UNITED STATES PATENT AND TRADEMARK OFFICE

Office Action Summary

09/986,844

DETAILED ACTION

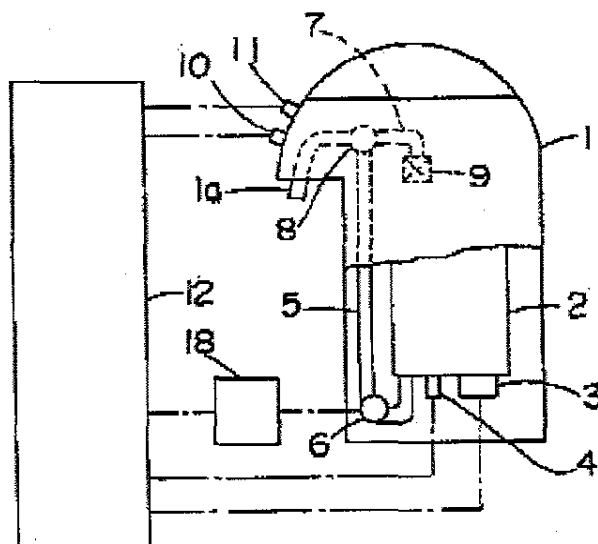
3. Claims 1-4 are rejected under 35 U.S.C. 103(a) as being unpatentable over JP 8-206000, hereinafter '000 in view of JP 7-59660, hereinafter '660 and JP 57014141, hereinafter '141. For explanatory purposes, figure 1 of '000 has been reproduced on the next page.

As shown above, '000 teaches a portable water dispenser that includes an inner container 2, heater 3 and pump 6 therebelow the container and a filter 9 thereabove. The water flow pipe 5 is arranged such that water from the container can be recycled thereto or dispensed from outlet 1a [as in claim 1], wherein the reflux mouth (end of pipe 7) is higher than the filtered water outlet 1a [as in claim 3]. As for claim 4 the filter 9 would inherently include a plurality of holes at a bottom thereof in order to perform the filtering function [as in claim 4].

图 1

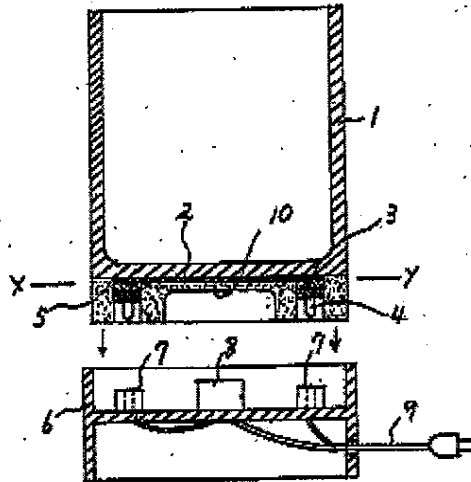
'000 does not explicitly disclose the container 2 to be made of glass. However, such is known in the art of '141. Figure 1 of which is reproduced on the next page.

As shown above, '141 teaches a container 1 for heating water that is made of glass (see the English abstract) [as in claim 1]. It is considered that it would have been obvious to one ordinarily skilled in the art at the time of the invention to have the container 2 of '000 to be glass, as in '141, since '141 teaches the benefit of "a transparent material that is heat and shock resistant.

【圖1】

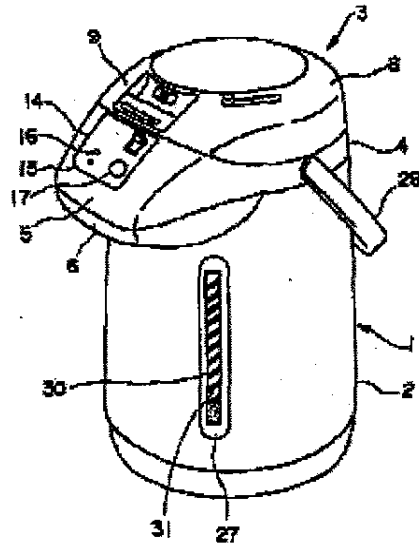
However, such is known in the prior art of '660. Figure 1 of '660 has been reproduced on the next page.

As shown above, '660 teaches a button 17 for dispensing water. It is considered that it would have been obvious to one ordinarily skilled in the art at the time of the invention to have the button of '660 in the invention of '000 since '660 teaches the benefit of dispensing heated water upon demand from a portable water thermos—a goal of '000.

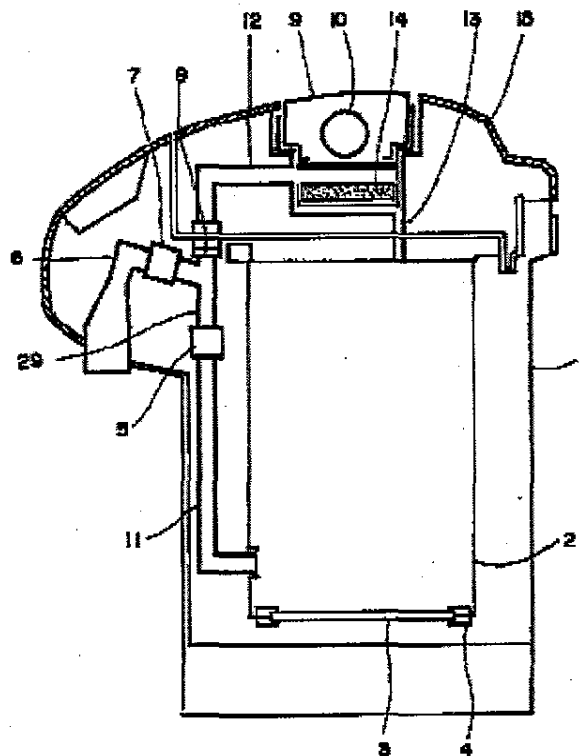
As for claim 2, '660 also teaches a window 27 [as in claim 2]. It is considered that it would have been obvious to one ordinarily skilled in the art at the time of the invention to have the window of '660 in the invention of '000, as modified by '441, since '660 teaches the benefit of indicating to the user how much water is in the inner container. Such would allow the user to know when water needs to be added to the device and also prevent operation when the container is empty that could damage the pump.

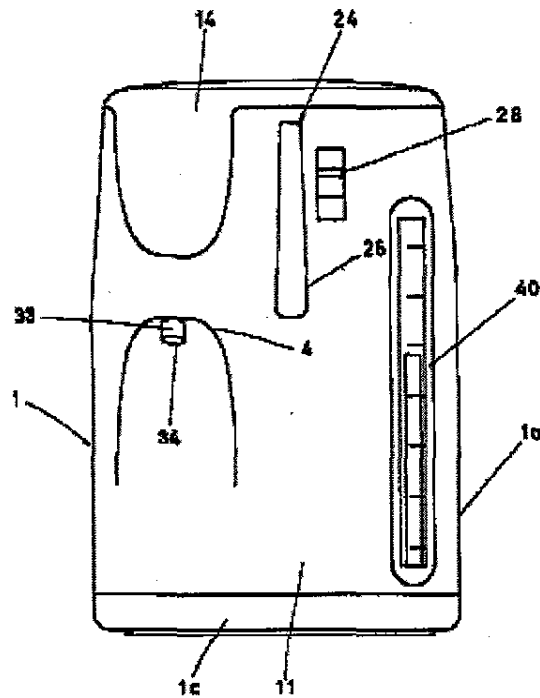
- JP 11-285448 teaches a transparent window 40.
